STATE OF FLORIDA
DEPARTMENT OF TRANSPORTATION

FINAL "AS-BUILT" PLANS

FINANCIAL PROJECT ID 422396-1-52-01

STATE ROAD NO. 546

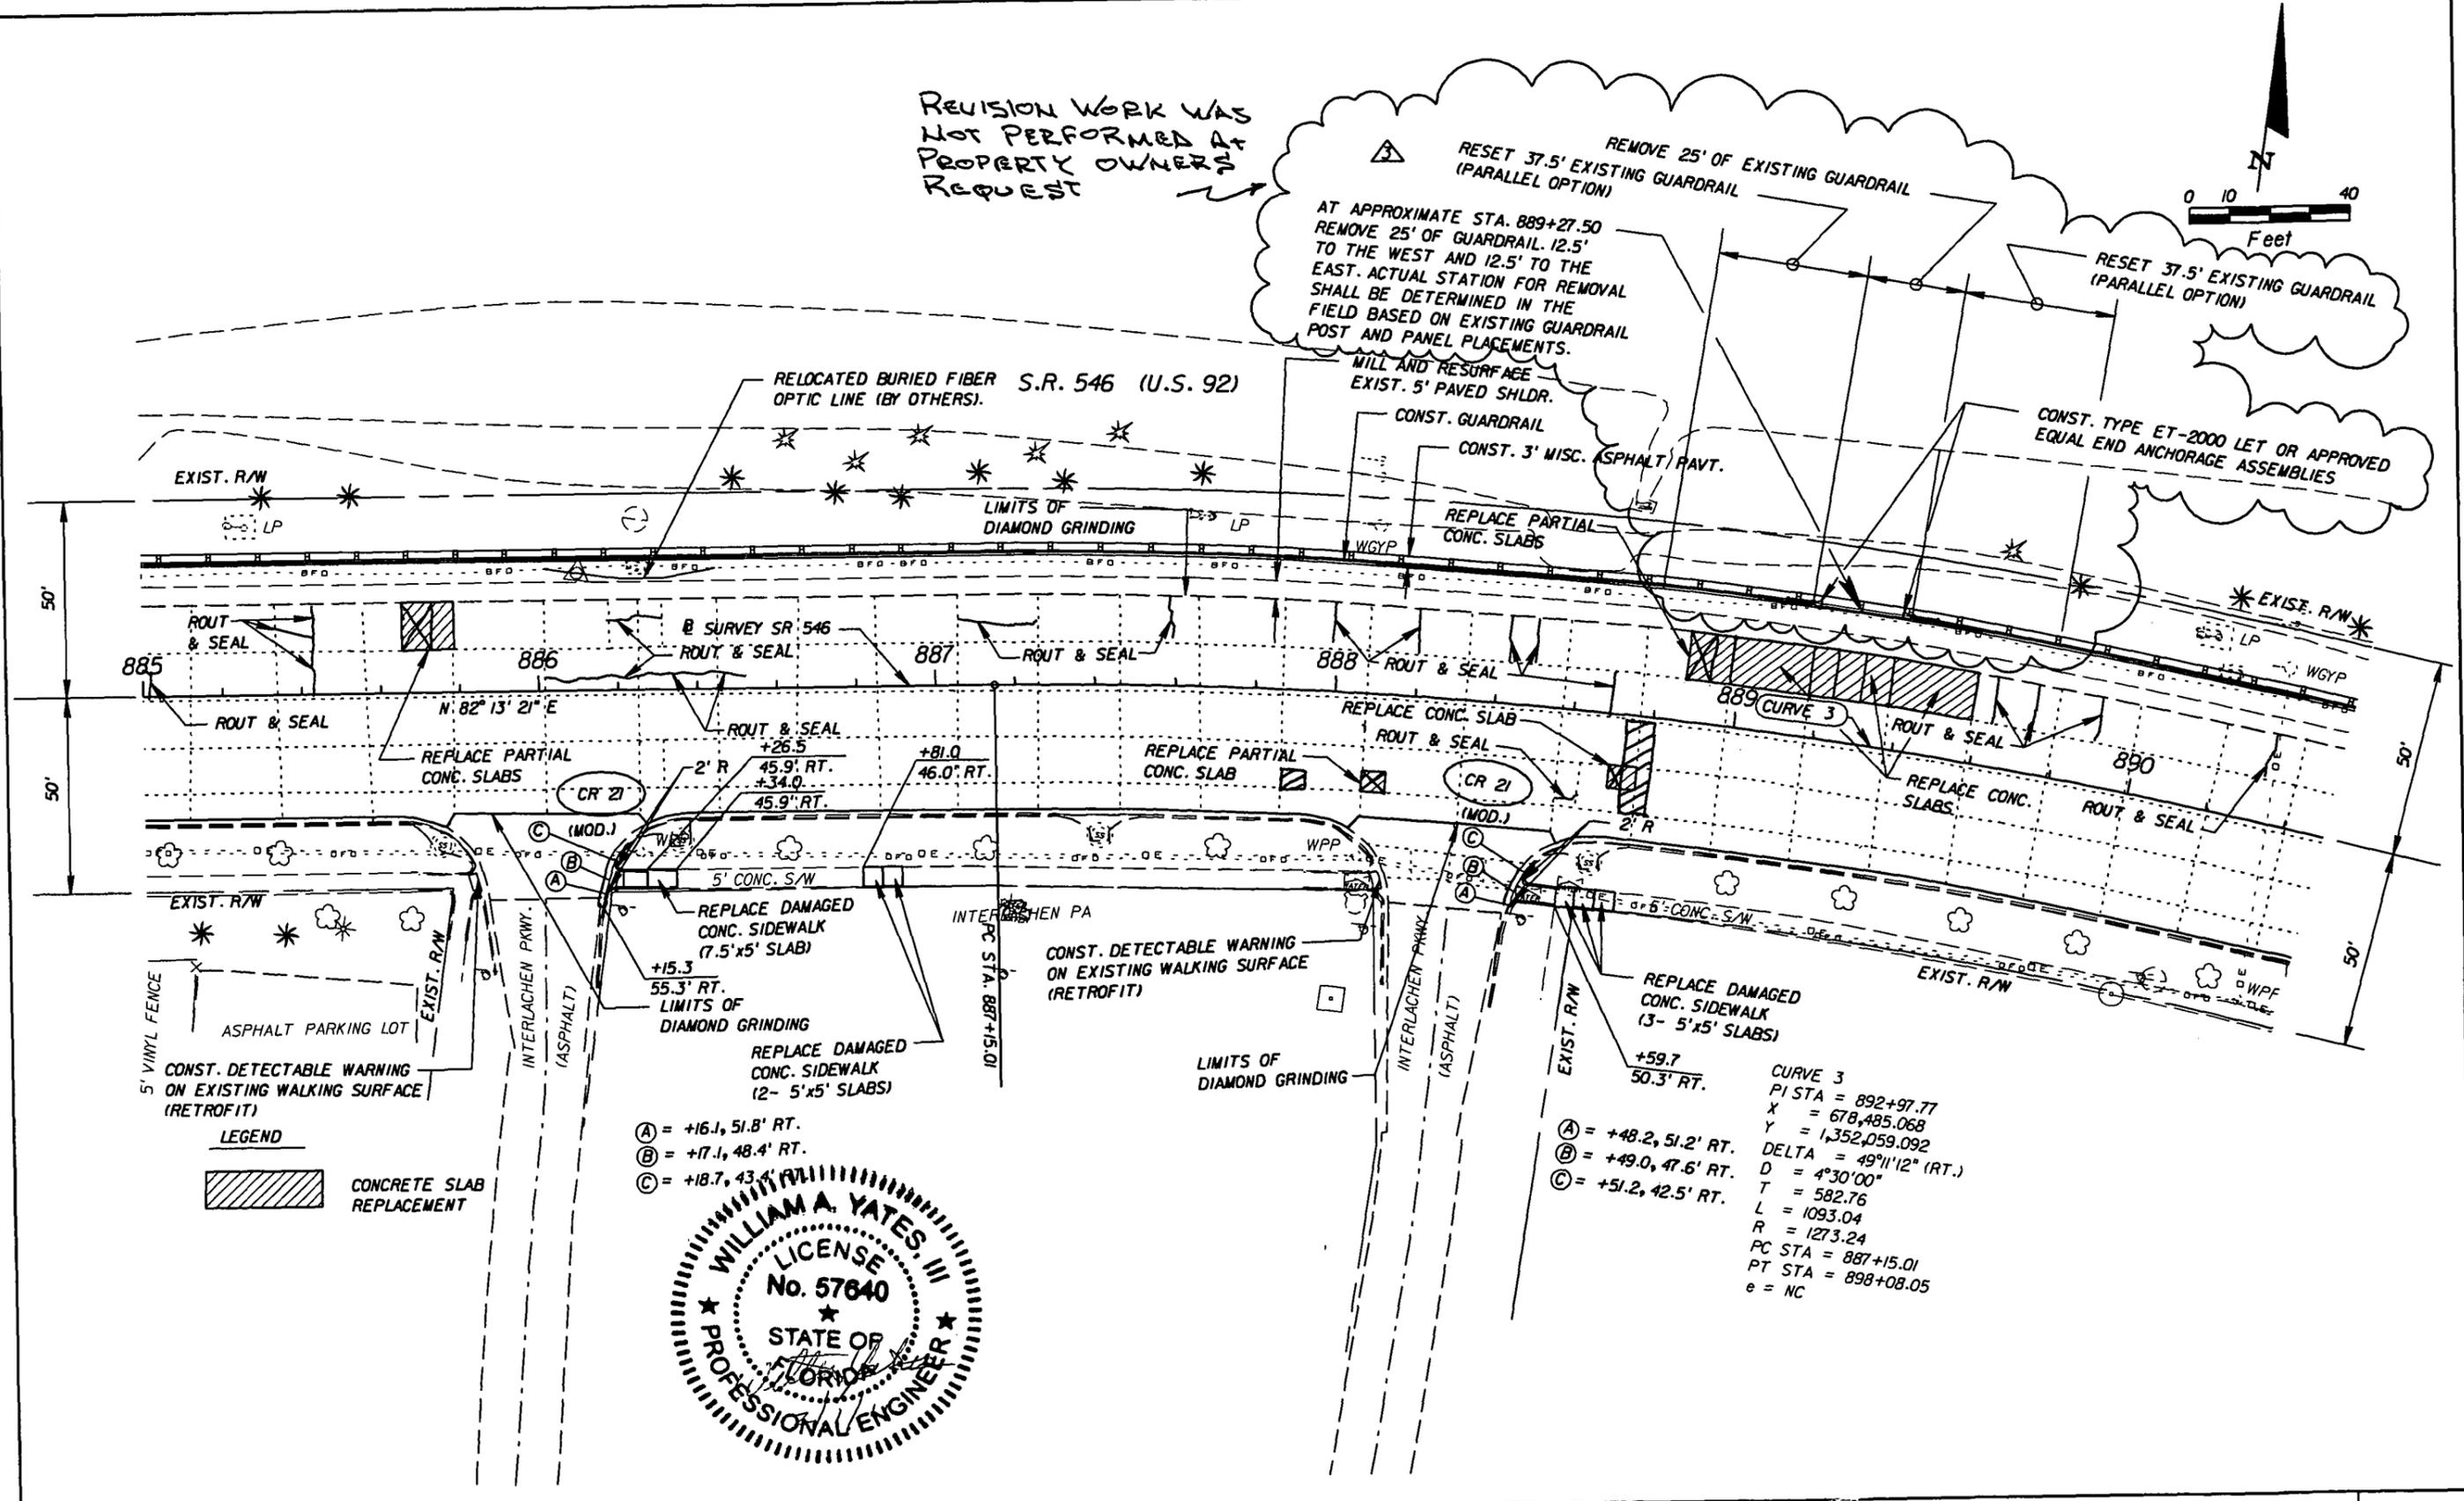
REVISION WORK WAS NOT PERFORMED AT PROPERTY OWNERS REQUEST
